NOTICE TO CONTRACTORS BIDDING THIS PROJECT

Project Title: Building and Site Improvements at 6741 Downing Avenue, Bakersfield, CA

Contract No: 26016

ADDENDUM No. 9

C5B

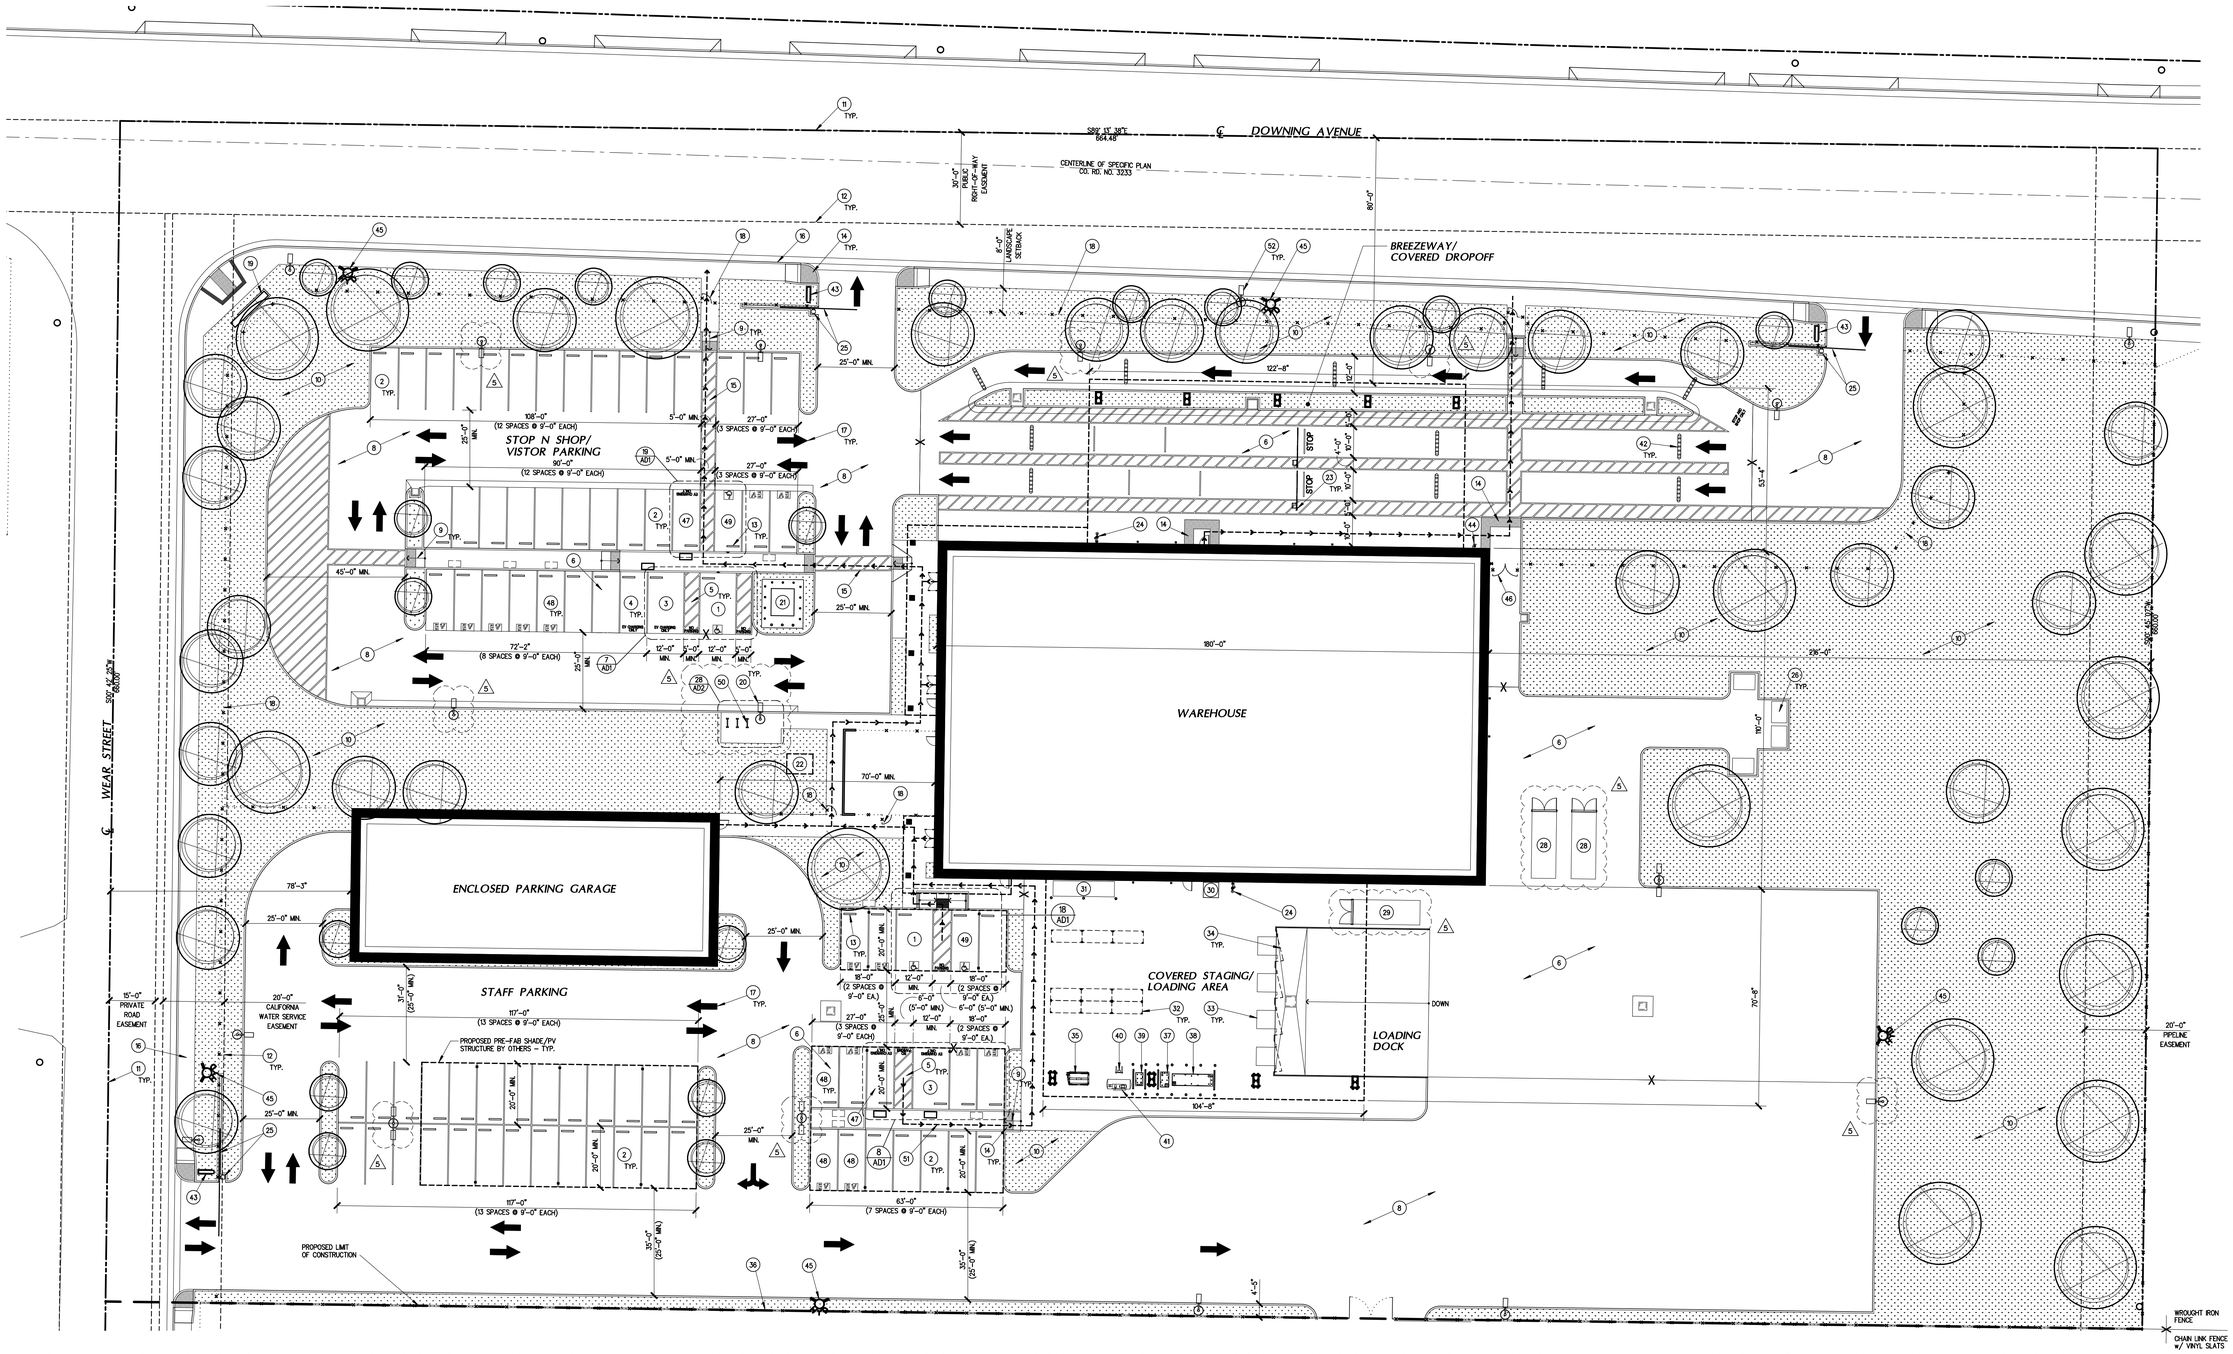
b. Sheet C5A has been replaced with sheet C5B. The irrigation POC has been revised to a 1" size. The revised sheet is attached to this addendum.

JOB 7005	
DP AC/JV	A100C
PM GJF

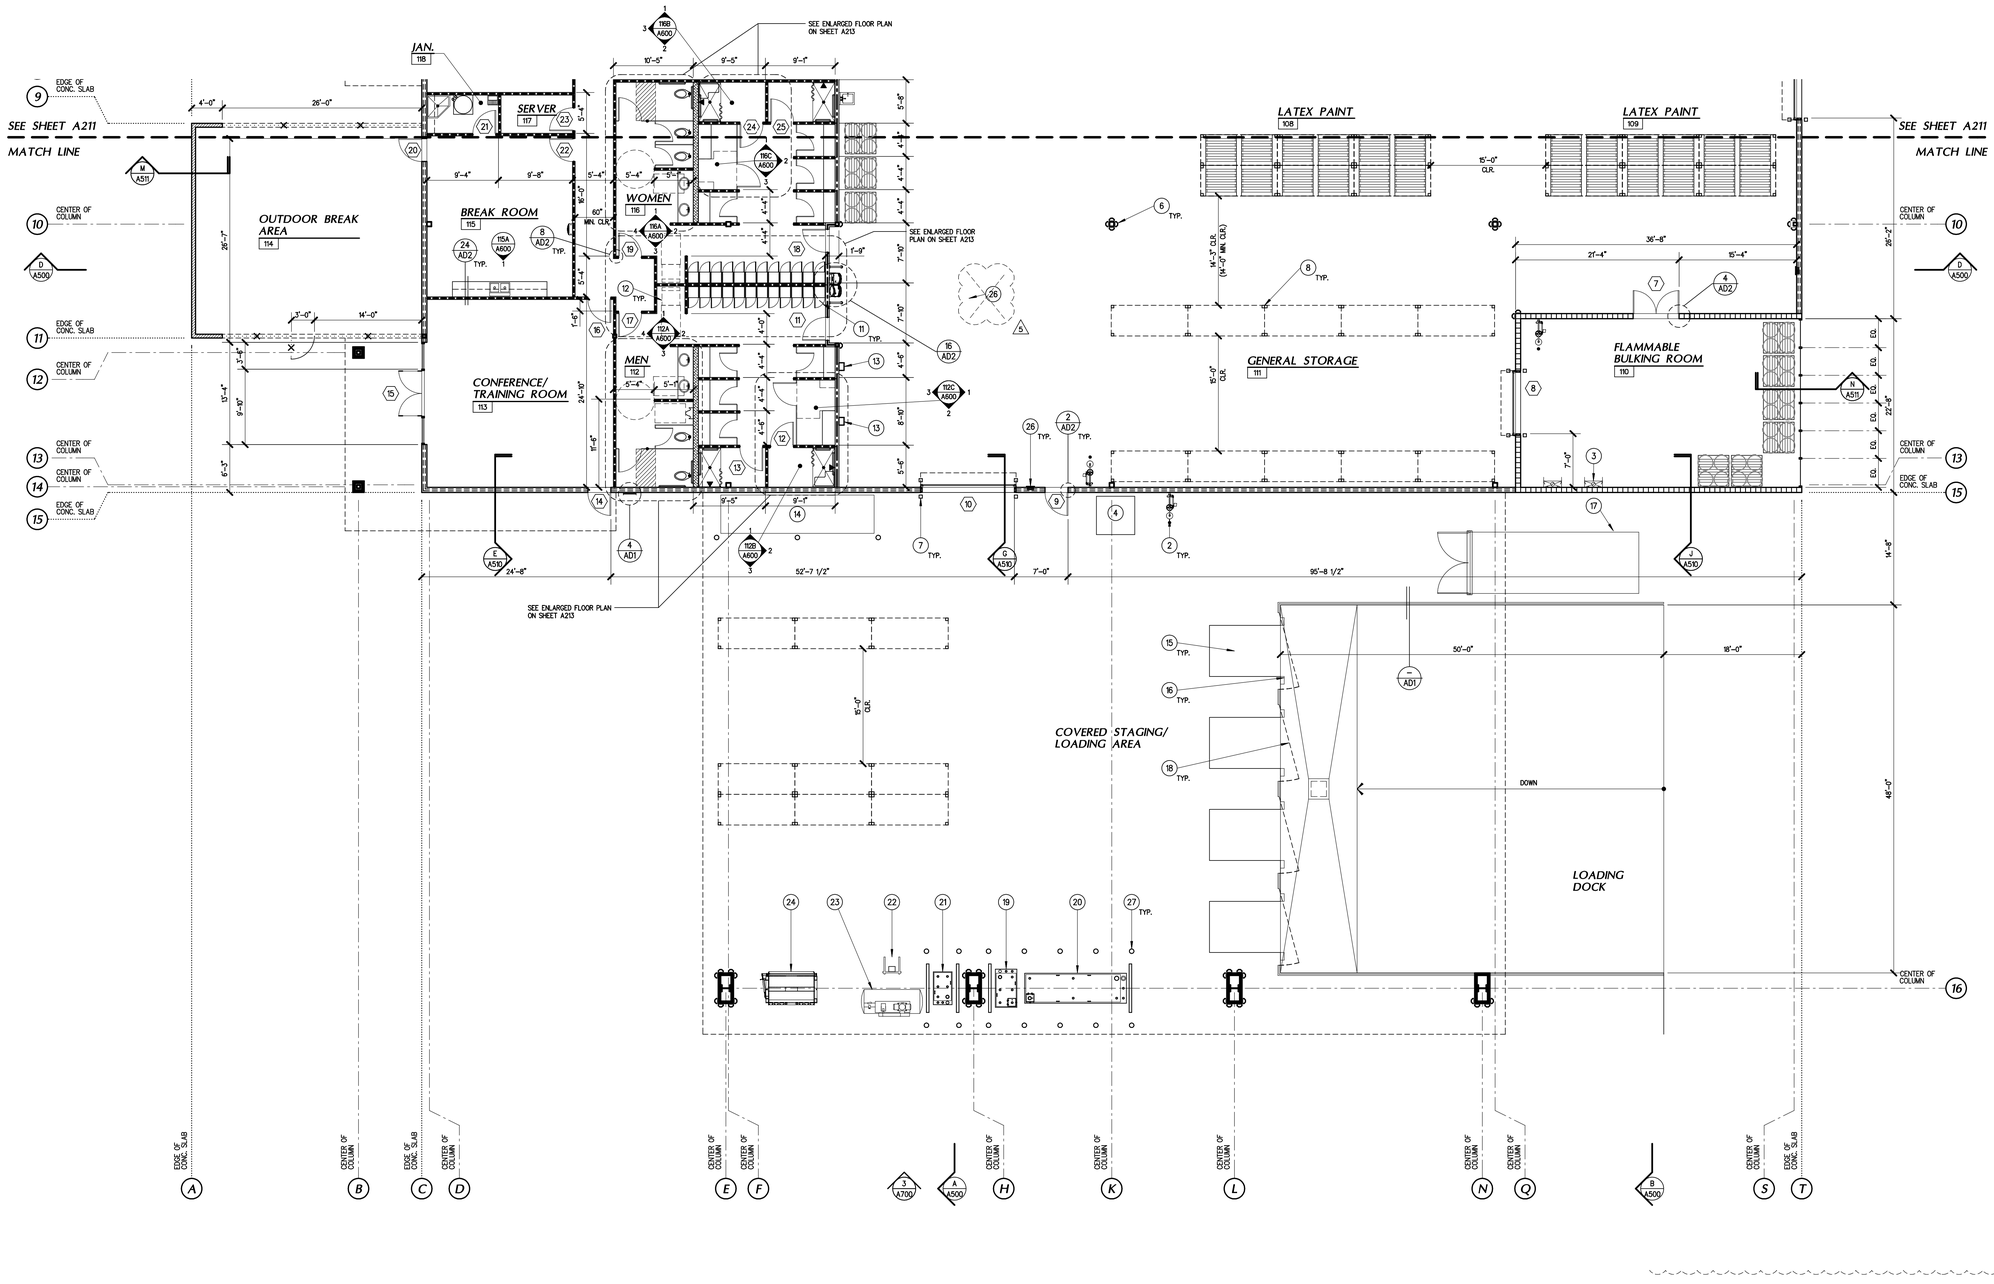
c. Sheet A100B has been replaced with sheet A100C. Dock leveler, restraint, and bumper specifications have been added. Garbage and latex bins have been clarified to be provided by owner. In-ground scale specification has been provided. The revised sheet is attached to this addendum.

JOB 7005	
DP AC/JV	A214C
PM CJF

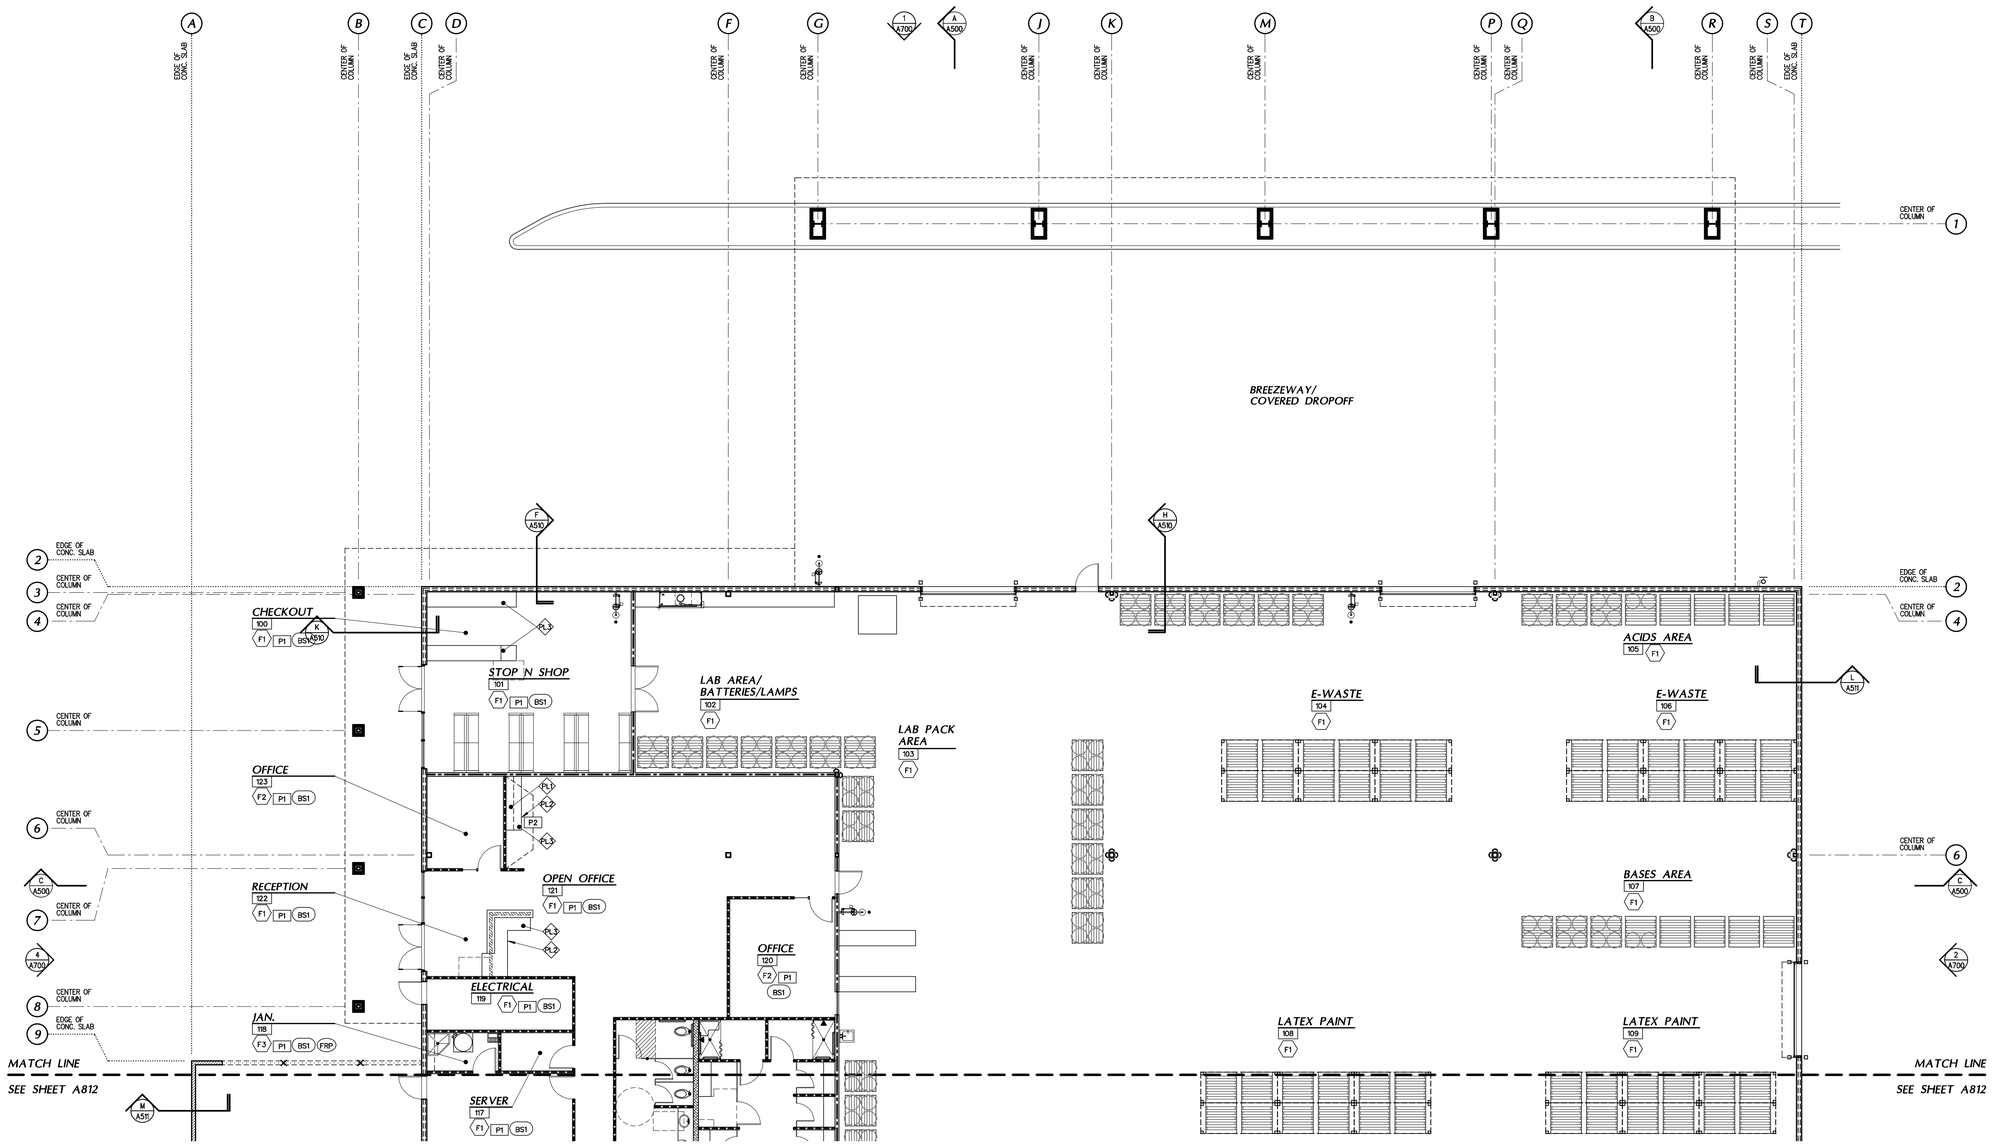
e. Sheet A214B has been replaced with sheet A214C. Additional glazing information has been added for clarification. The revised sheet is attached to this addendum.

JOB 7005	
DP AC/JV	A811C
PM GJF

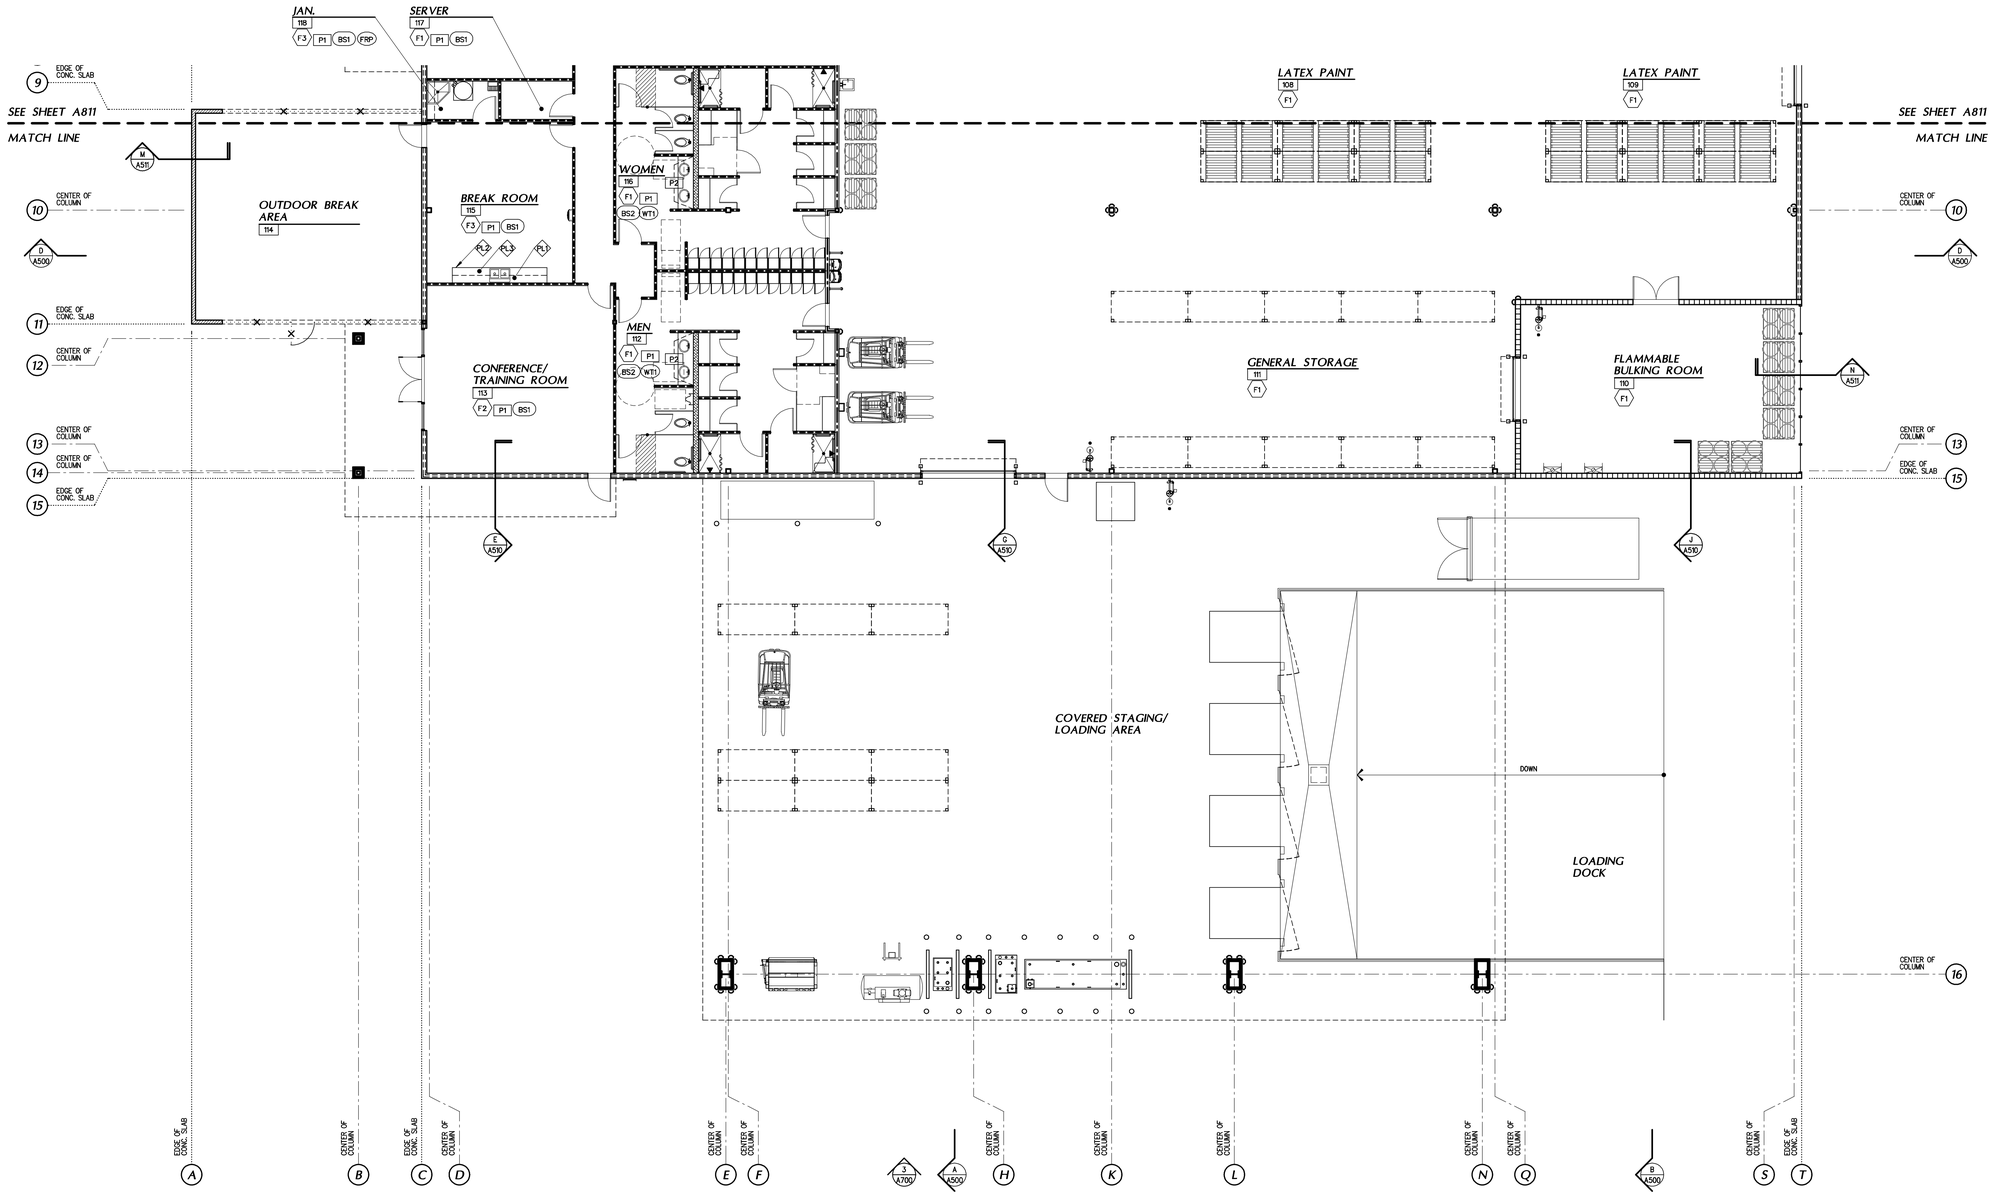
f. Sheets A811B & A812B have been replaced with sheets A811C & A812C. The FRP manufacturer has been corrected. The revised sheets are attached to this addendum.
